# 4 UNIT APARTMENT BUILDING 93 ST. LAWRENCE STREET LARRY GROSS AND BARBARA COLBY PORTLAND, MAINE

On behalf of Larry Gross and Barbara Colby (Applicants), Sevee & Maher Engineers, Inc. (SME) has prepared this response to comments made by City staff in regards to the multi-family building proposed at 93 St. Lawrence Street. Comments from City Staff were provided in an email dated August 27, 2015. The comments and associated responses are detailed below.

Subject: Application ID 2015-120  
93 St. Lawrence Street  
Larry Gross and Barbara Colby  
Response to City Staff Comments

C-101

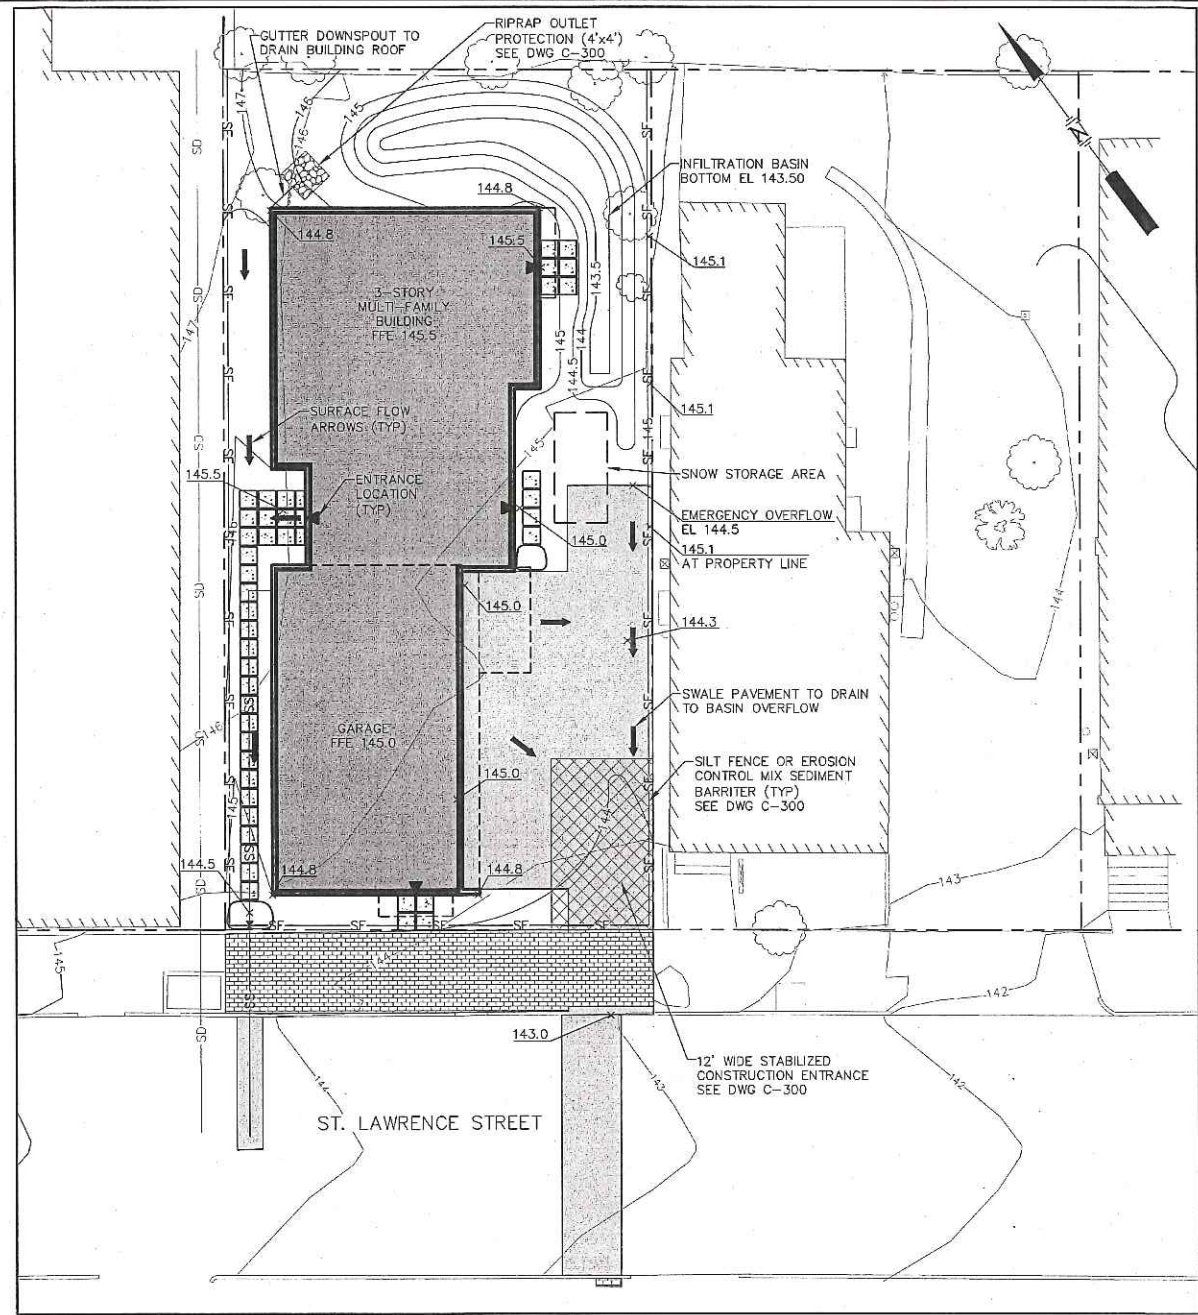
2. The plans propose connecting the development's sanitary sewer lateral into a manhole in the street. No manhole exists at that location. Please show the lateral connecting directly into the sewer main in the street using acceptable City standards.  
SME Response: The sewer lateral connection was revised on Drawing C-101 to tie into the sewer main with a tee/wye connection.

3. The existing sidewalk a curbing abouting this project is in poor condition. The applicant is request to re-set the granite curbing and replace the brick walk meeting all City standards where possible.  
SME Response: Drawing C-101 has been revised to indicate new sidewalk pavers and curbing along the whole frontage of the company.

5. In accordance with Section 2.6.9 of the City's Technical Manual, all new (sewer) laterals connecting to a combined sewer system shall have a back water valve. The back water valve should be located on private property and a detail should be provided. SME Response: A back water valve was added to Drawing C-101 on the Applicant's property.

SME Response: Drawing C-101 has been revised to indicate new sidewalk pavers and curbing along the whole frontage of the property.

SME Response: Curbing will be provided along the whole frontage of the property as revised on Drawing C-101.

4 UNIT APARTMENT BUILDING  
93 ST. LAWRENCE STREET  
LARRY GROSS AND BARBARA COLBY  
PORTLAND, MAINE  
SUBDIVISION PLAT

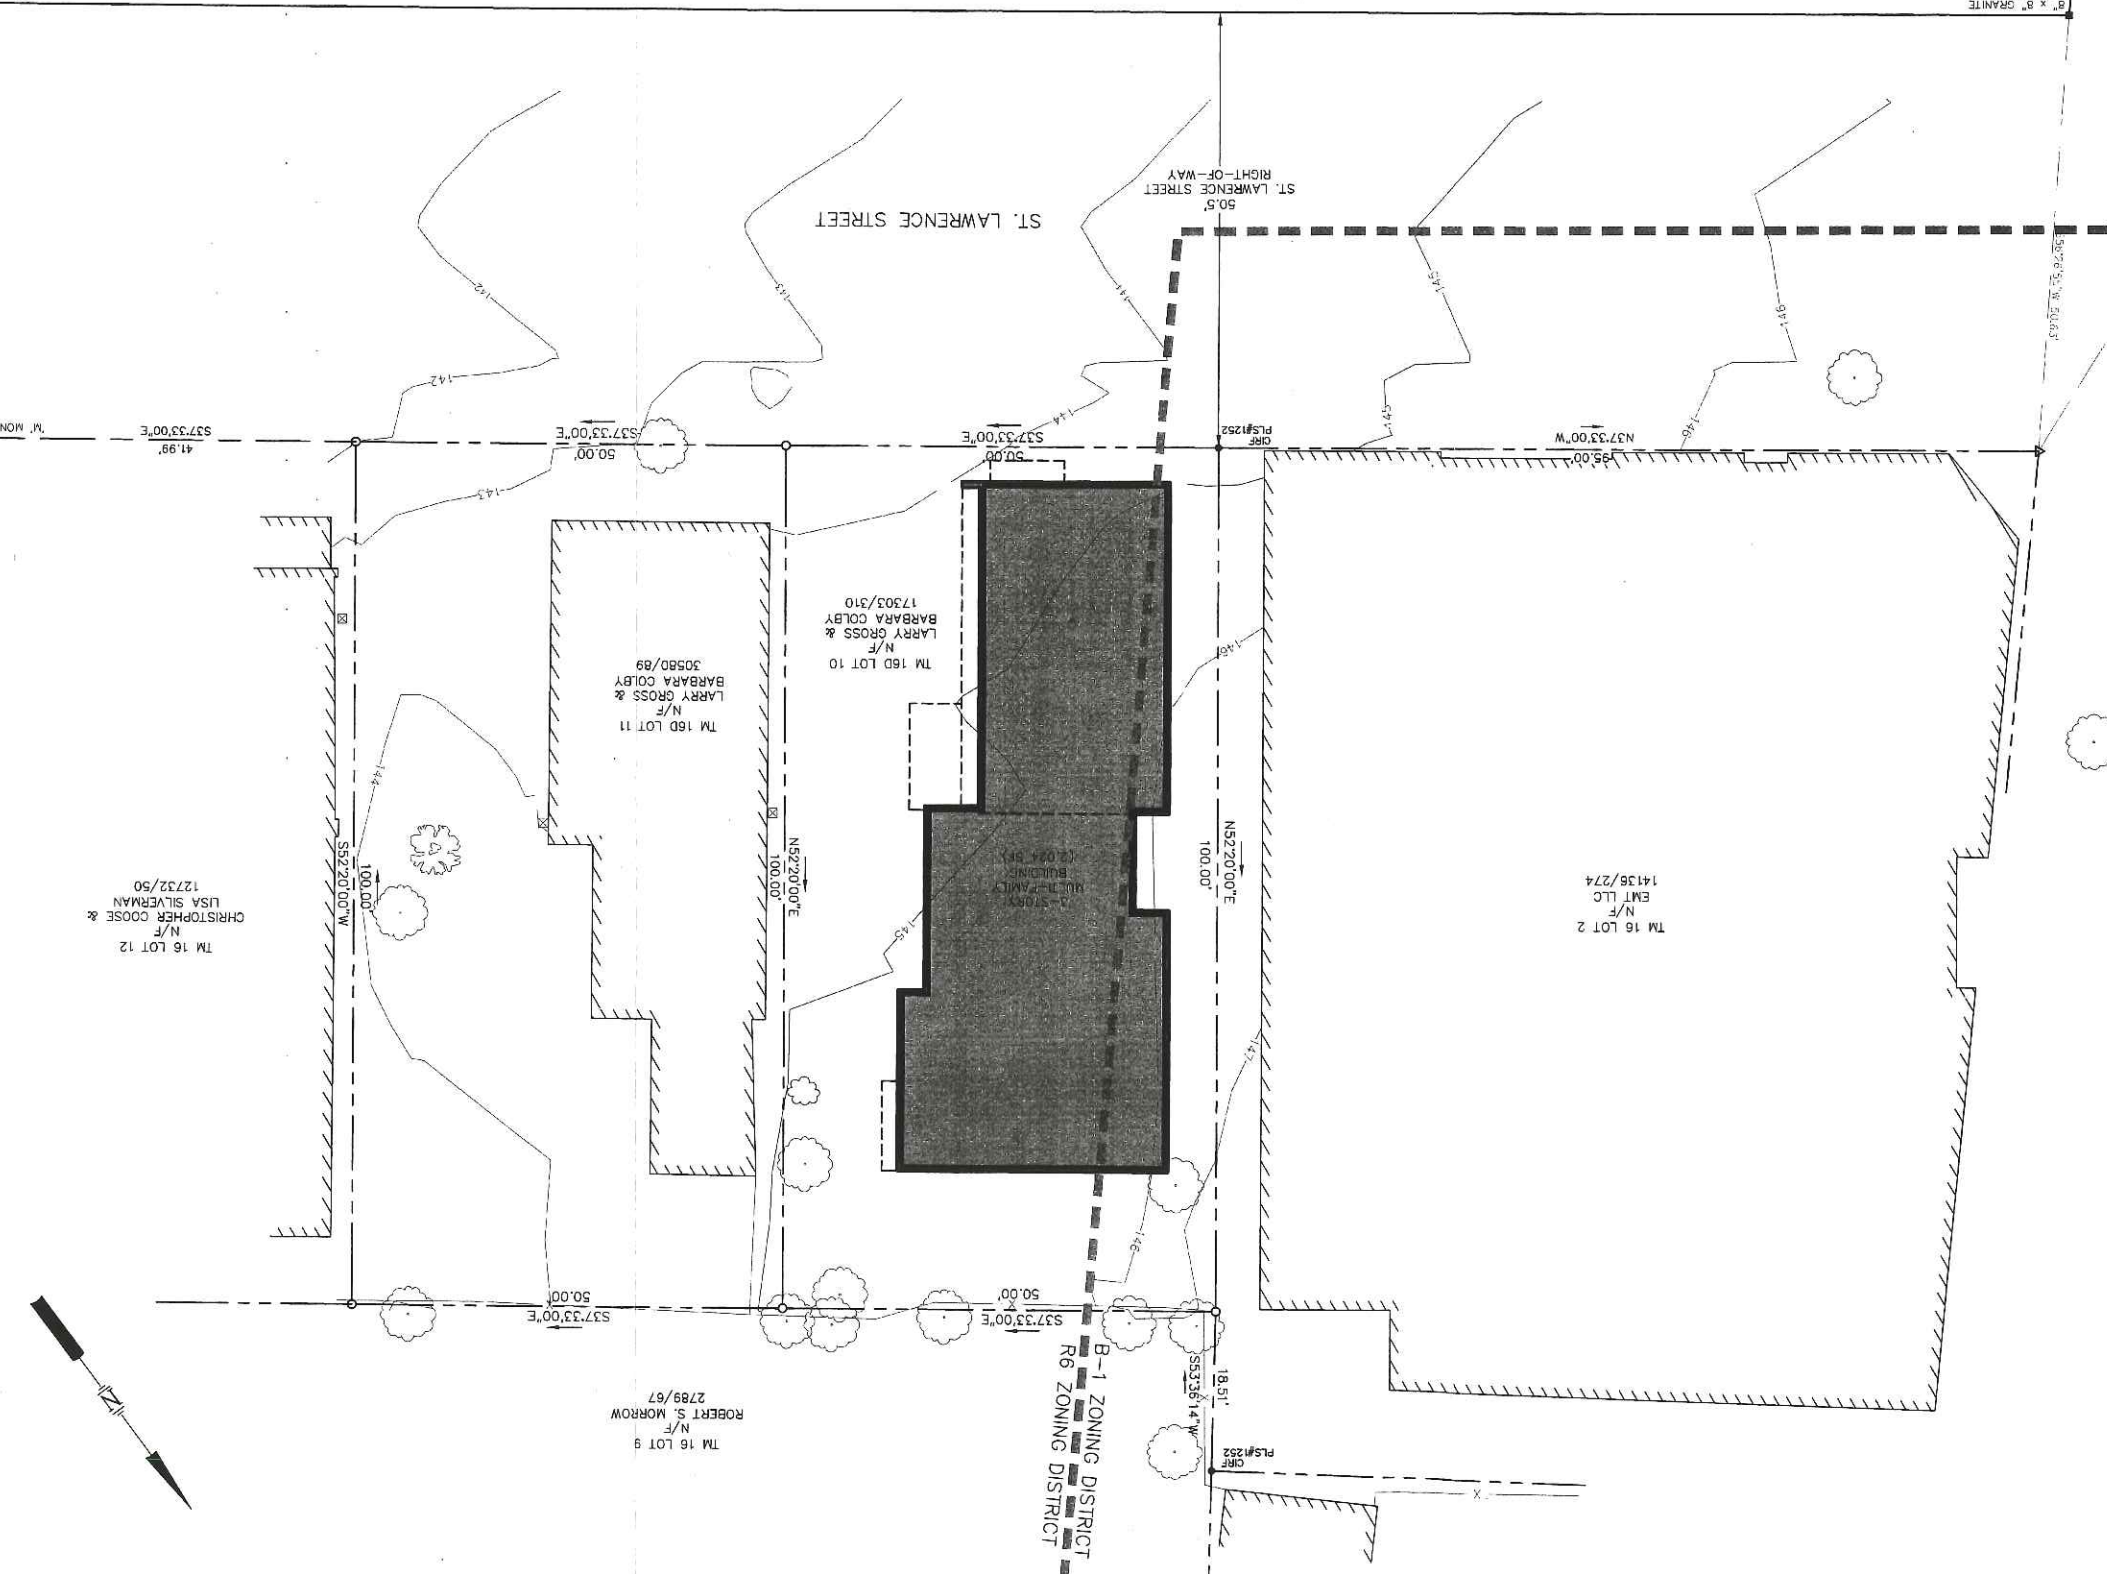
1. Subdivision Plat shall be submitted for review. The Plat shall show all easements (existing and proposed) on site.  
SME Response: A Subdivision Plat has been prepared and is included on Drawing C-101A in the drawing set.
2. Photometric and lighting plan needs to be replaced, as well as catalogue cuts.  
SME Response: Site lighting will be provided with light fixtures near the building entryways as shown on the Architectural Plans.
3. Landscaping Plan will need to be submitted.

L-1 LANDSCAPE PLAN

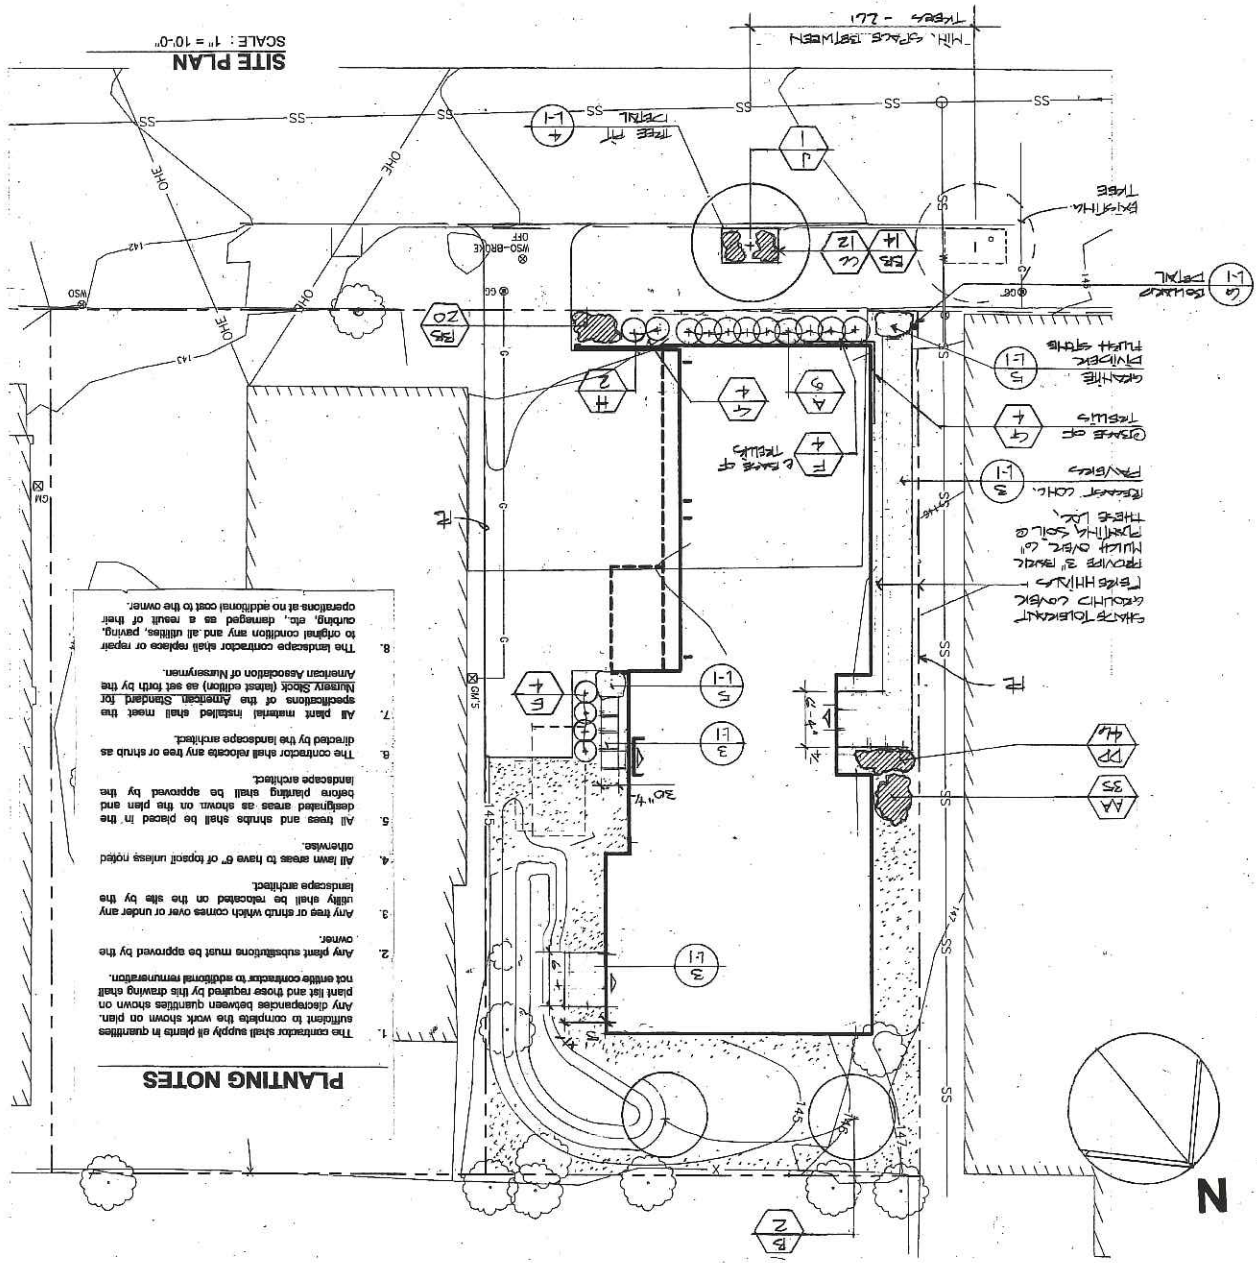
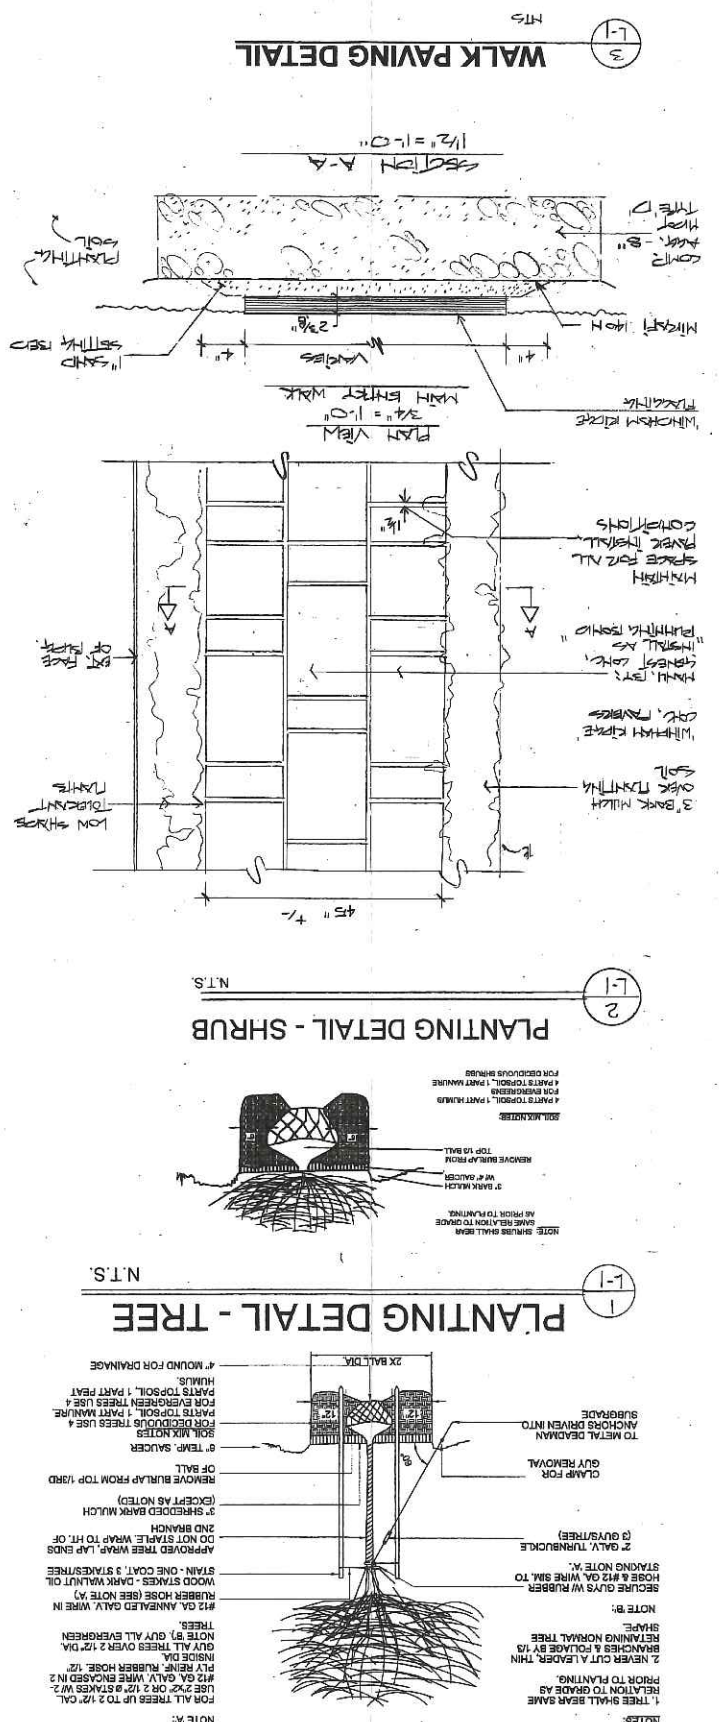
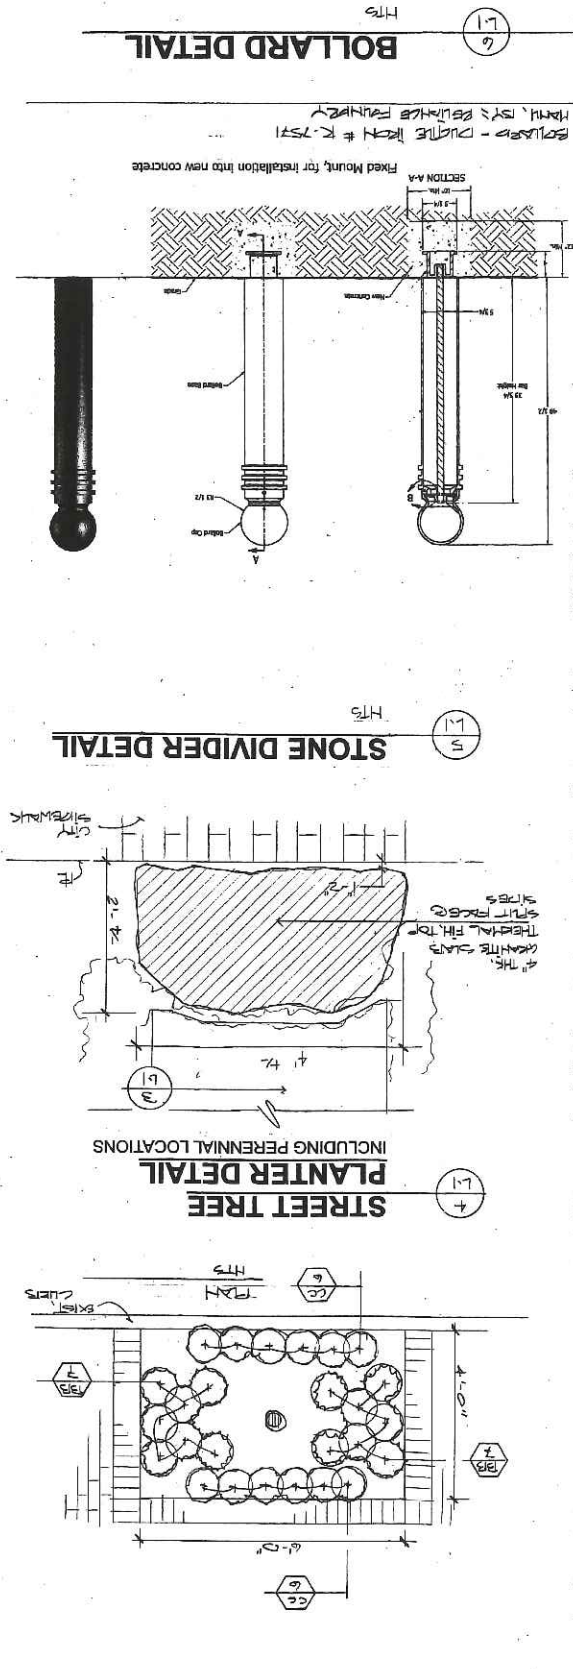
5. Street trees will need to be installed; requirement is one tree per unit, therefore four trees are required. If there is not space along the frontage, then the applicant can request a waiver and make a contribution to the City's Tree Fund of \$200 per tree. The preference is that there be attempt to plant the trees.

SME Response: The Landscaping Plan L.1 is included in the resubmitted drawing set.
